Late Backup
SPARKS ENGINEERING, INC.
STRUCTURAL EVALUATION, DESIGN AND TESTING

**SUBJECT: Initial Structural Assessment
3805 Red River**

RE: 3805 Red River; Case C14H-2014-0007

Figure 4 The interior floor slab is not supporting the exterior load-bearing walls, as seen here where the floor slab has settled independent of the walls.

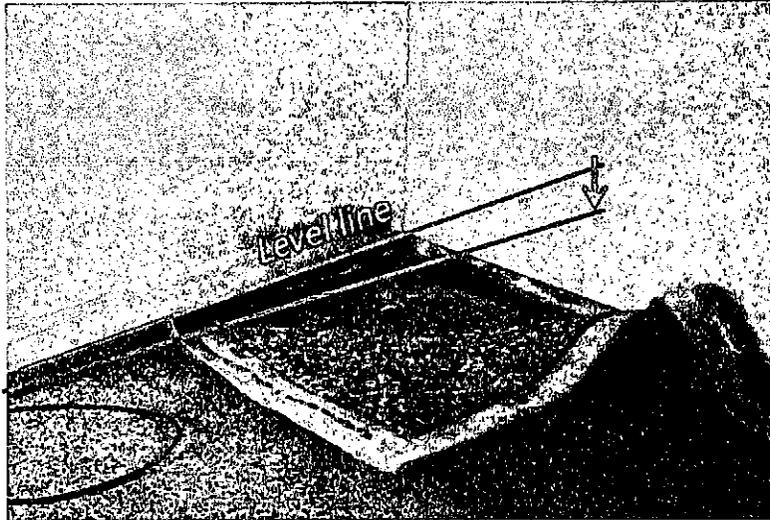
In my opinion, the structural foundation is not damaged, nor is the house unsafe as asserted in the report by Mirza Tahir Baig, P.E. of Professional StruCIVIL Engineers, Inc. dated May 19, 2014. Contrary to Mr. Baig's conclusions, the house is structurally stable. The exterior walls do not need to be underpinned. The interior floor slab can be replaced without disturbing the load-bearing exterior walls.
